Model: Stinger-C1 DF (DF68)	Date: 15-Jan-00	No.: MA859001a
-----------------------------	-----------------	----------------

Modified Article: Parts Catalog Correction		Prepared by: K. Miura	
From: Technical Services Dept., GTS Division			
Reason for Modification:	<input checked="" type="checkbox"/> Parts catalog correction	<input type="checkbox"/> Vendor change	<input type="checkbox"/> To meet standards ( )
	<input type="checkbox"/> To facilitate assembly	<input type="checkbox"/> To improve reliability	
	<input type="checkbox"/> Part standardization	<input type="checkbox"/> Other

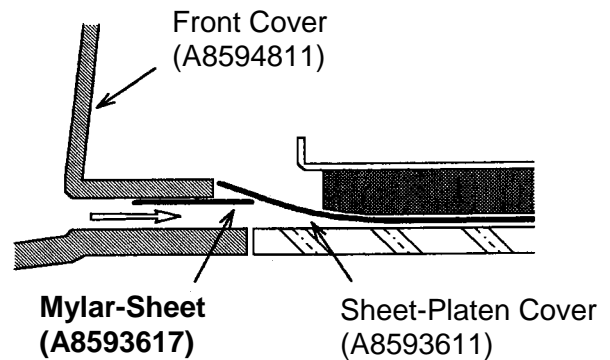
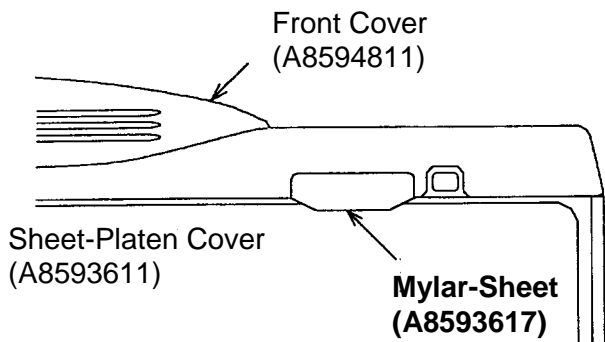
When the platen cover is closed and opened again, the white sheet on the inside of the cover touches the exposure glass and pulls up on the glass.

A sheet of mylar has been attached to the **front cover** to prevent it from touching the glass when the cover is closed (see the illustration).

Old part number	New part number	Description	Q'ty	Int	Page	Index	Note
	A8593617	Mylar - Sheet	1		3	23

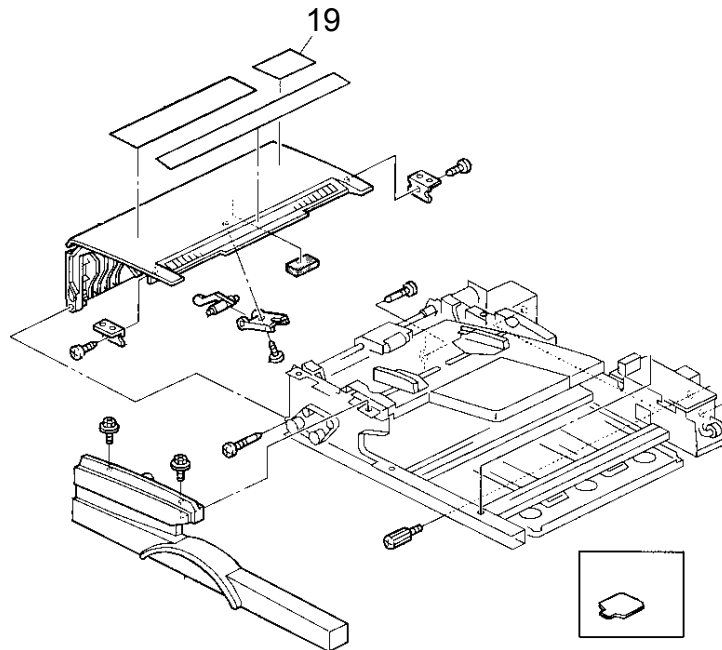
For purposes of parts standardization with existing and new models yet to be released, the exposure glass decal has been changed.

Old part number	New part number	Description	Q'ty	Int	Page	Index	Note
A8596052	A8586062	Decal - Exposure Glass	1	O/O	3 17	19 7

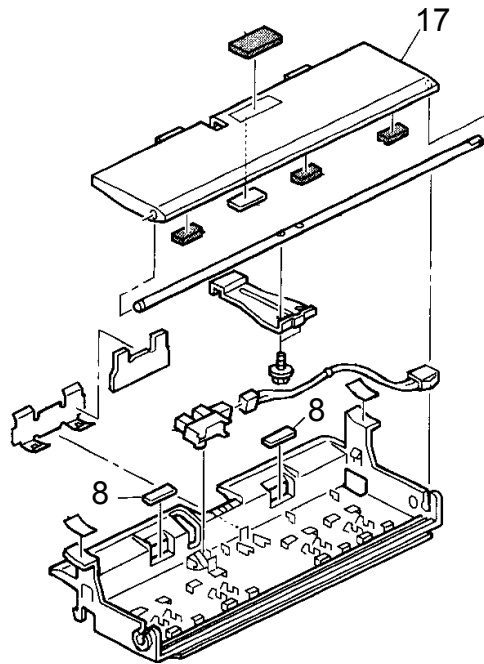
The material of the cushion base has been changed to ensure that #17 (Base - Paper Feed) will separate paper to feed the original smoothly.

Old part number	New part number	Description	Q'ty	Int	Page	Index	Note
A8592318	A8592319	Cushion Base	2	X/O	5	8

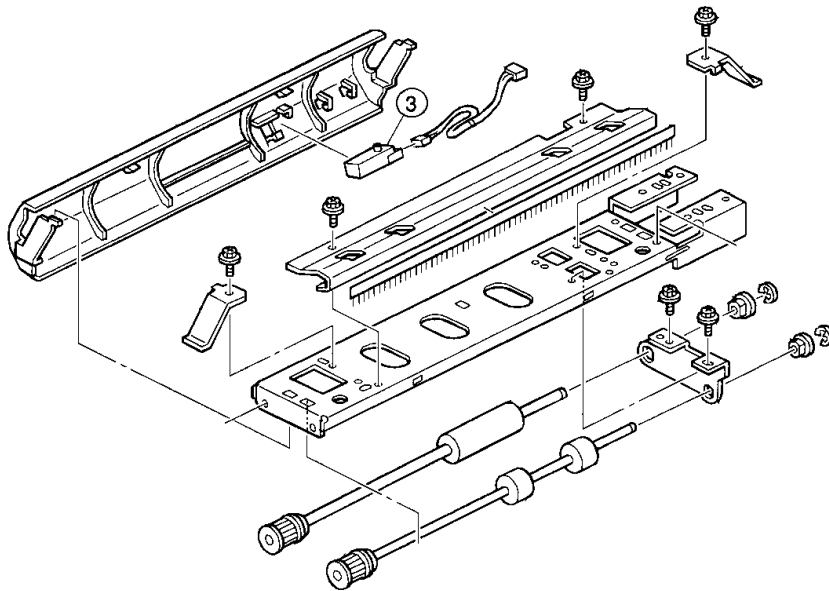
The vender for the following part has been changed.

Old part number	New part number	Description	Q'ty	Int	Page	Index	Note
AW010076	AW010093	Photo Sensor – PS – 117ND1	1	O/O	11	3

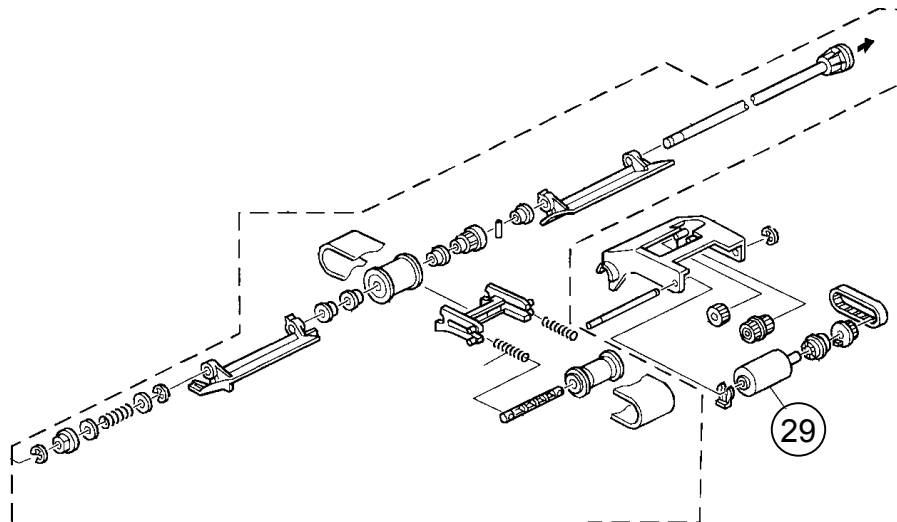
For parts standardization with other models, the pick-up roller has been changed as follows.

Old part number	New part number	Description	Q'ty	Int	Page	Index	Note
A8592161	B3862171	Pickup Roller	1	O/O	7	29

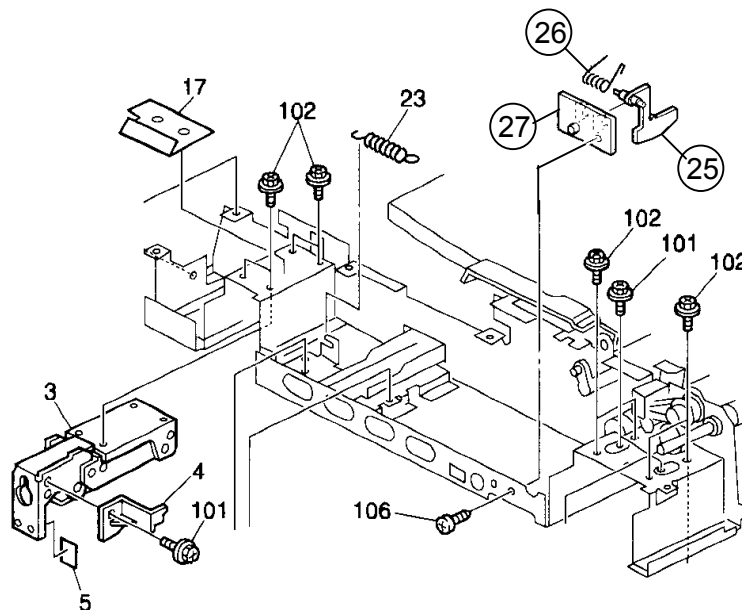
If large originals are set on the exposure glass under the APS Feeler, the feeler can damage the original when the ADF is closed.

The two fused sections of the Feeler (#25, 27 below) have been separated and a spring added so that the Feeler will retract inside the DF upon contact.

Old part number	New part number	Description	Q'ty	Int	Page	Index	Note
A8591121		Feeler – APS	1	X/O	13	24	
	B3861125	APS Feeler	1		13	25	A
	B3871951	Spring – Paper Size Sensor	1		13	26	A
	B3861121	APS Feeler Bracket	1		13	27	A

**Note:** These three parts should be replaced together as a set.

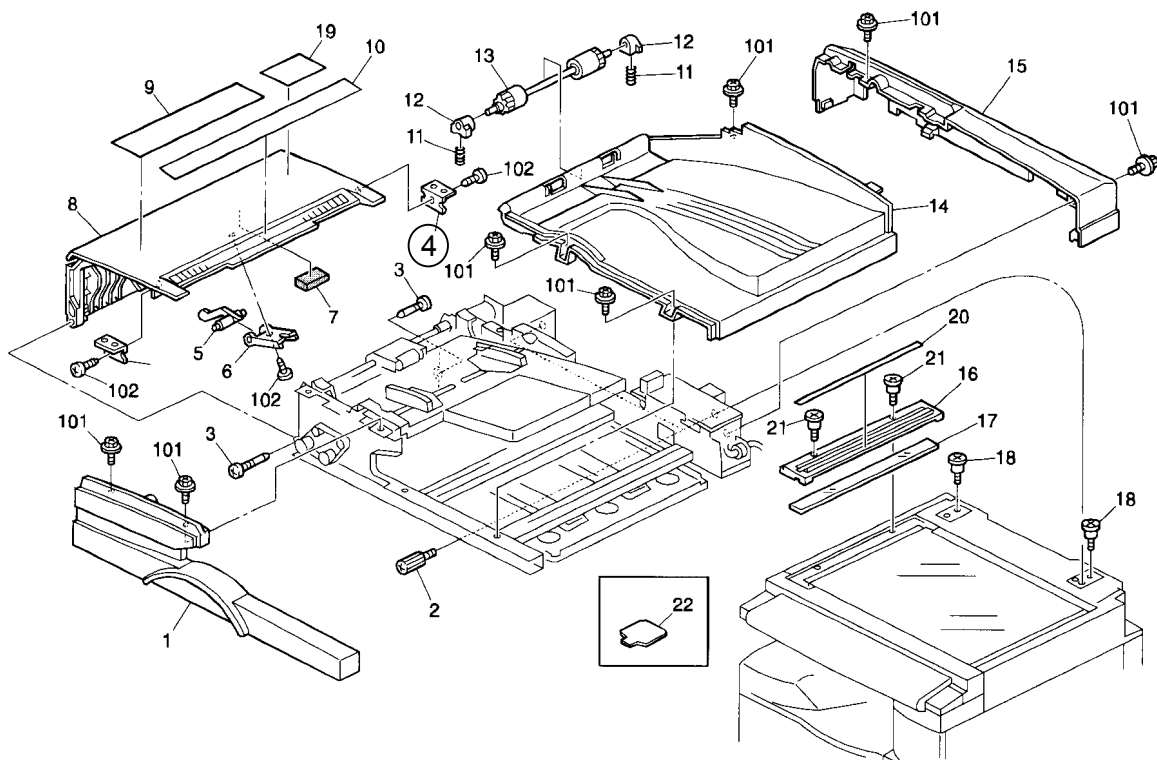
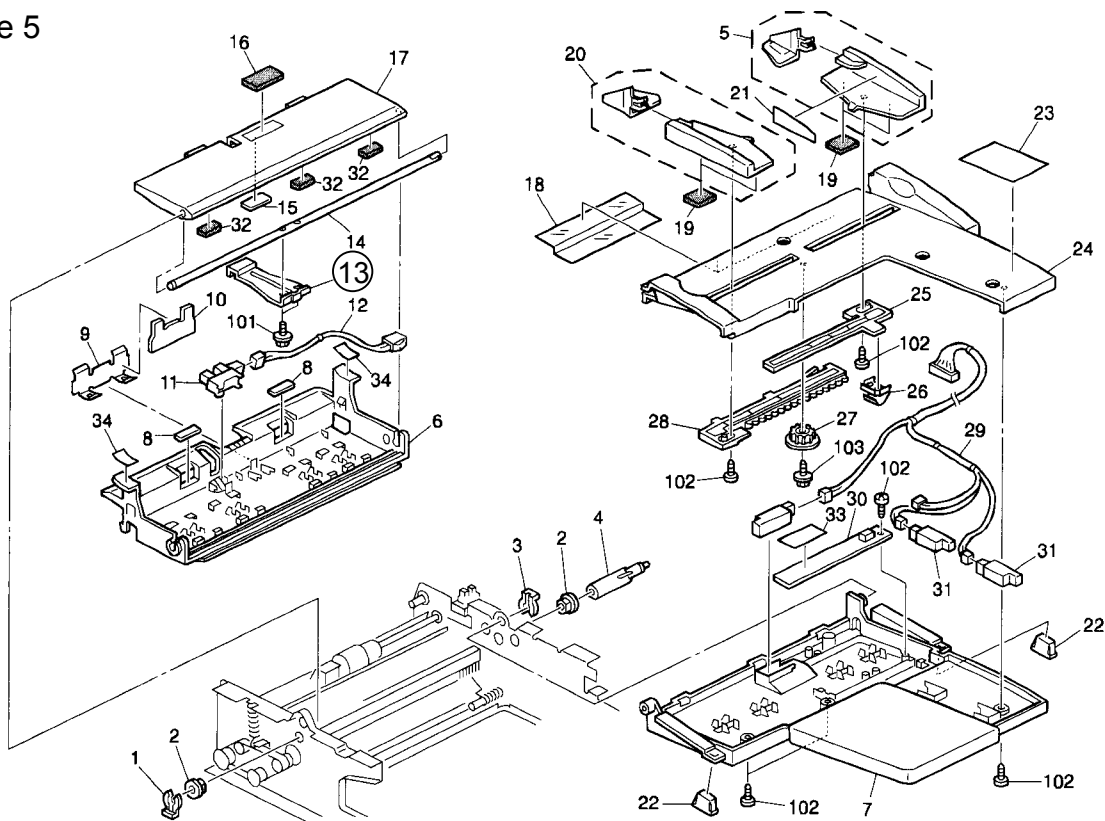
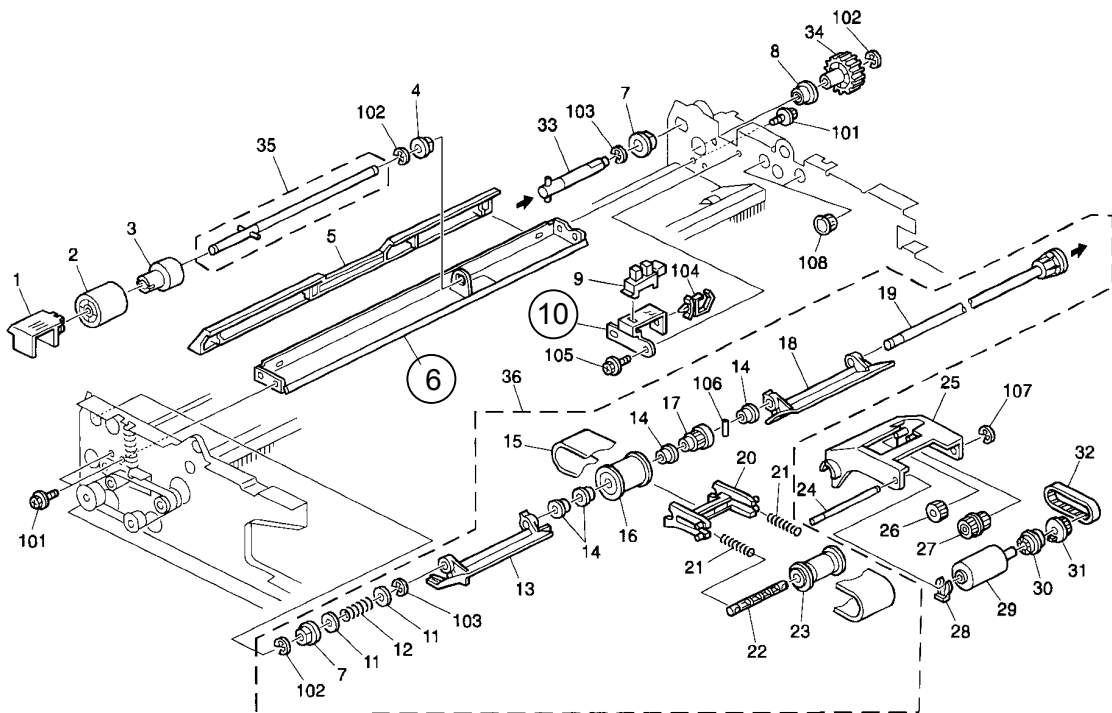
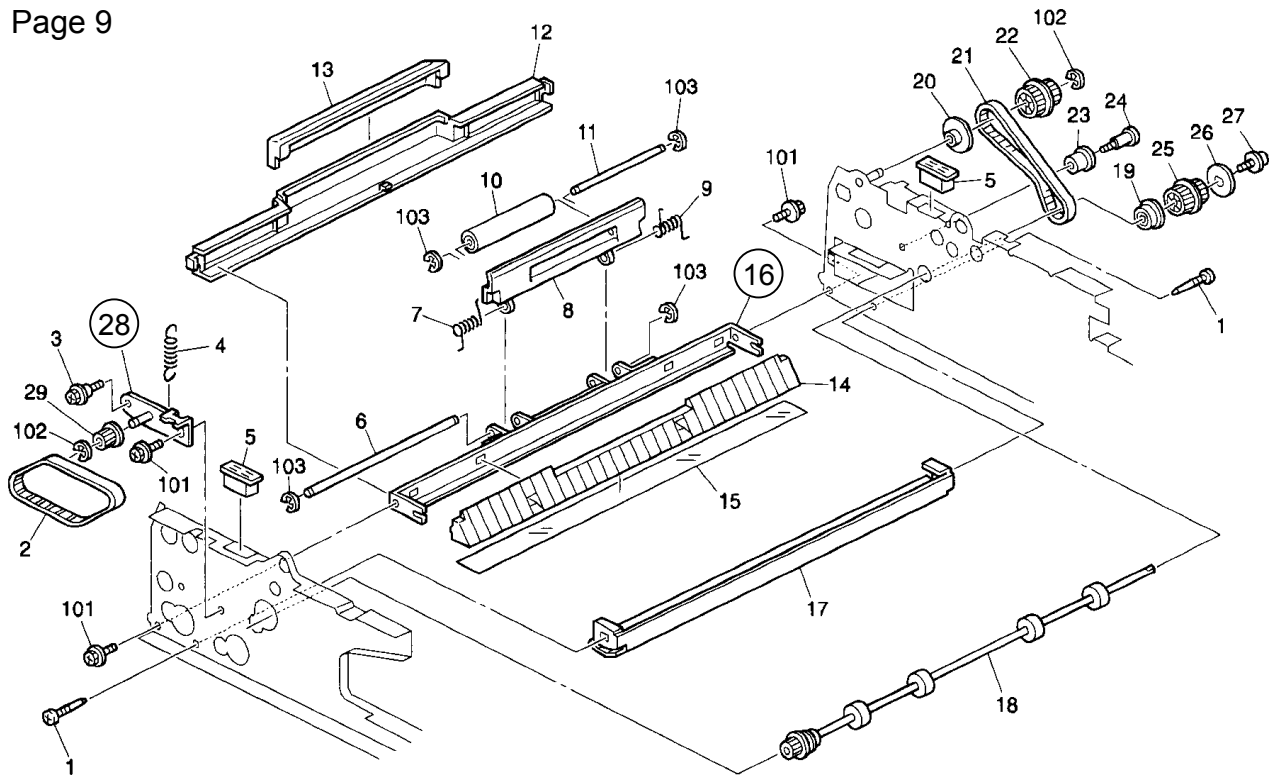
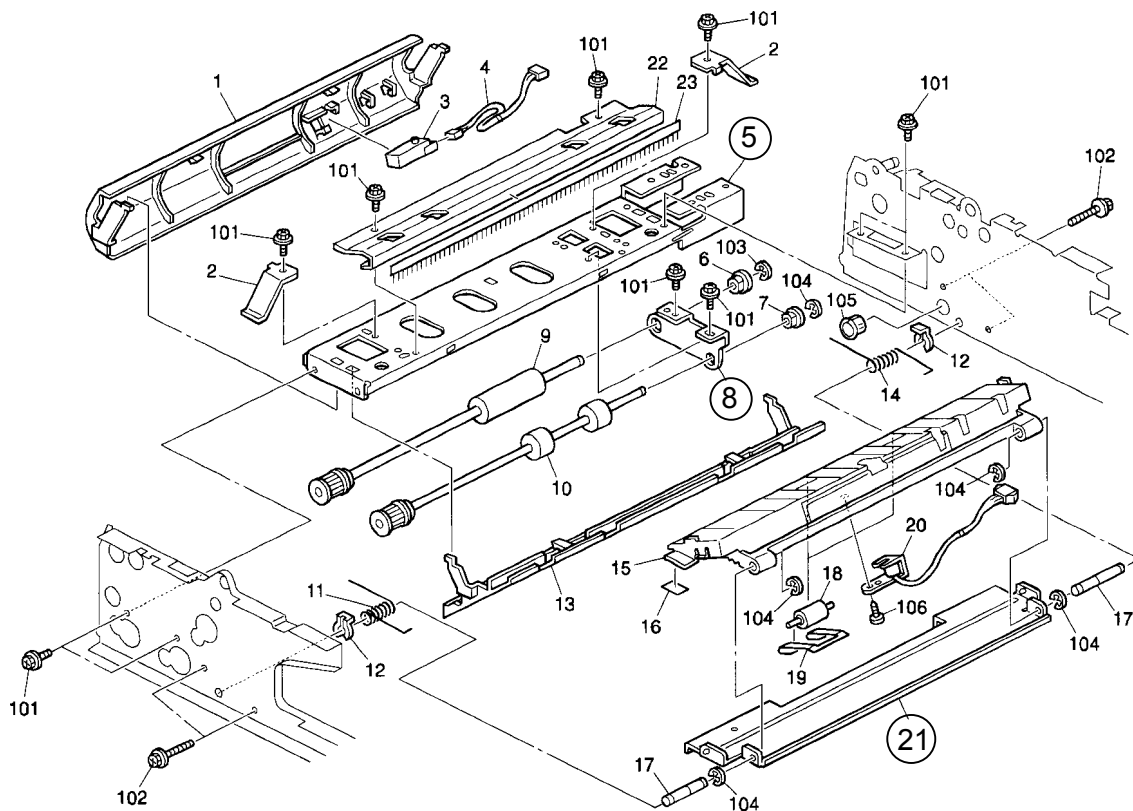
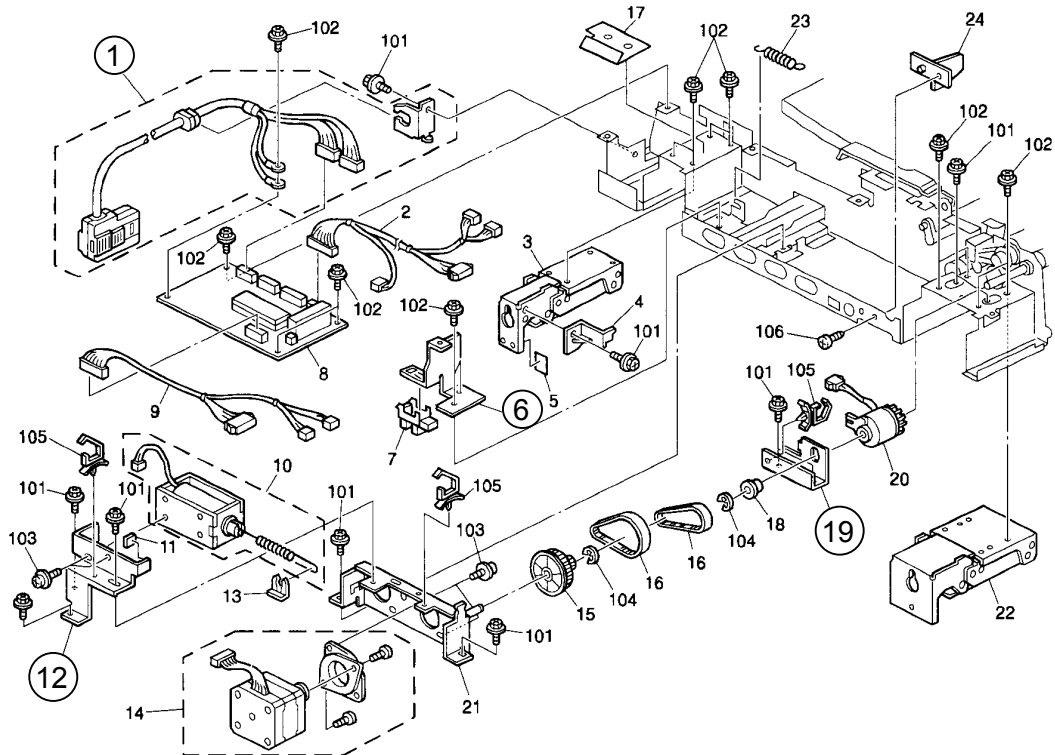
The material for all brackets in the table below has been changed, and in accordance with this, the P/N for all other parts listed has also been changed.

Old part number	New part number	Description	Q'ty	Int	Page	Index	Note
A8594873	B3864873	Positioning Plate	2	O/O	3	4	
A8592353	B3862353	Pressure Plate – Base	1	O/O	5	13	
A8591610	B3861610	Separation Stay	1	O/O	7	6	
A8591123	B3861123	Sensor Bracket	1	O/O	7	10	
A8591710	B3861710	Left Lower Stay	1	O/O	9	16	
A8594311	B3864311	Adjusting Pin	1	O/O	9	28	
A8591311	B3861311	Left Stay	1	O/O	11	5	
A8591320	B3861320	Bracket - Transport Roller	1	O/O	11	8	
A8593413	B3863413	Cover - Exit Guide Plate	1	O/O	11	21	
A8595800	B3795800	Harness - Interface	1	O/O	13	1	
A8591122	B3861122	Right Sensor Bracket	1	O/O	13	6	
A8594411	B3864411	Bracket – Solenoid	1	O/O	13	12	
A8591315	B3861315	Bracket – Electromagnetic Clutch	1	O/O	13	19	
A8591511	B3861511	Middle Stay	2	O/O	15	3	
A8593615	B3863615	Base - Platen Cover	1	O/O	15	6

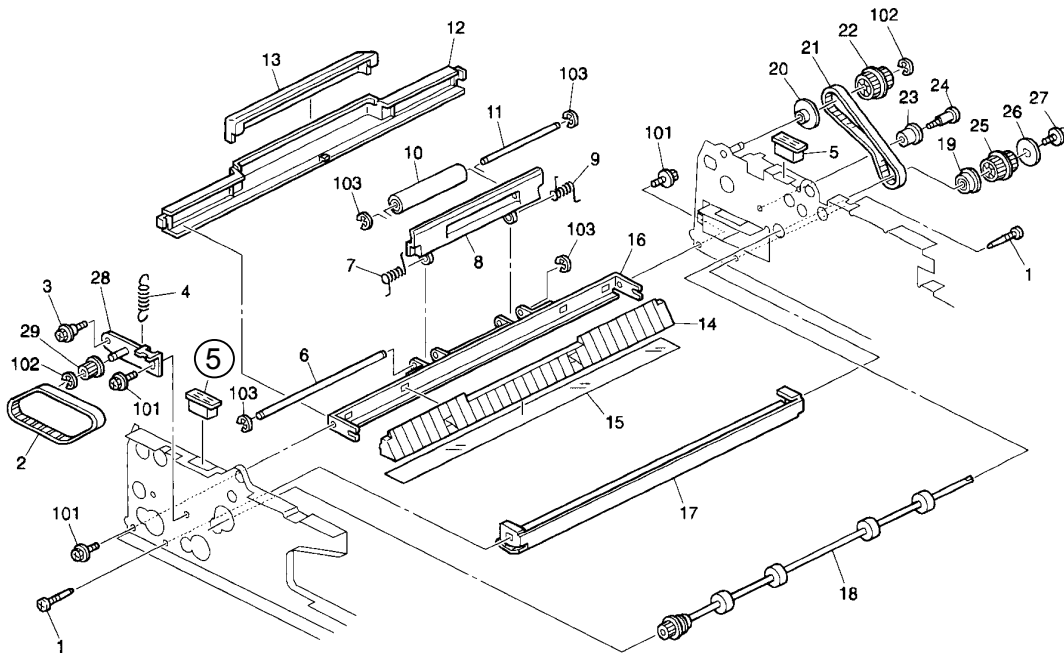
The following part has been changed due to a vendor change:

Old part number	New part number	Description	Q'ty	Int	Page	Index	Note
A8591181		Magnet Catch	1		9	5	
	B3514135	Magnet Catch - Original Table	1	O/O	9	5

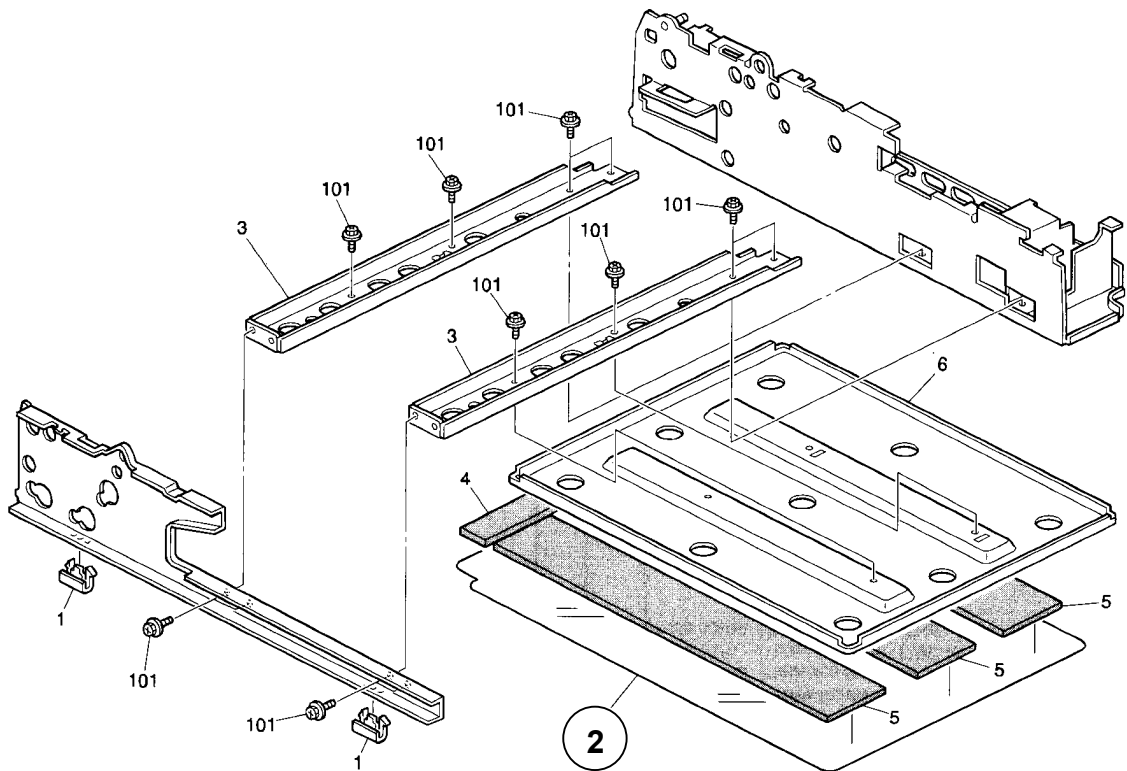
To standardize the platen cover sheet for several models, the following part has been changed:

Old part number	New part number	Description	Q'ty	Int	Page	Index	Note
A8593611	G4123721	Sheet - Platen Cover	1		15	2	
		Platen Cover Sheet	1	X/O	15	2

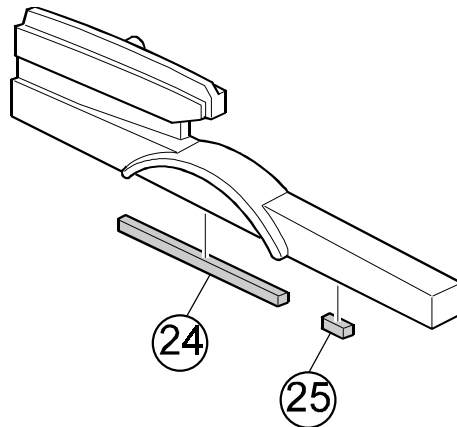
The following protective padding has been added to facilitate easier handling of the Platen Cover sheet.

New part number	Description	Q'ty	Page	Index	Note
A8584871	Cover Sponge - Front	1	3	24	
A8584872	Cover Sponge - Front Right	1	3	25
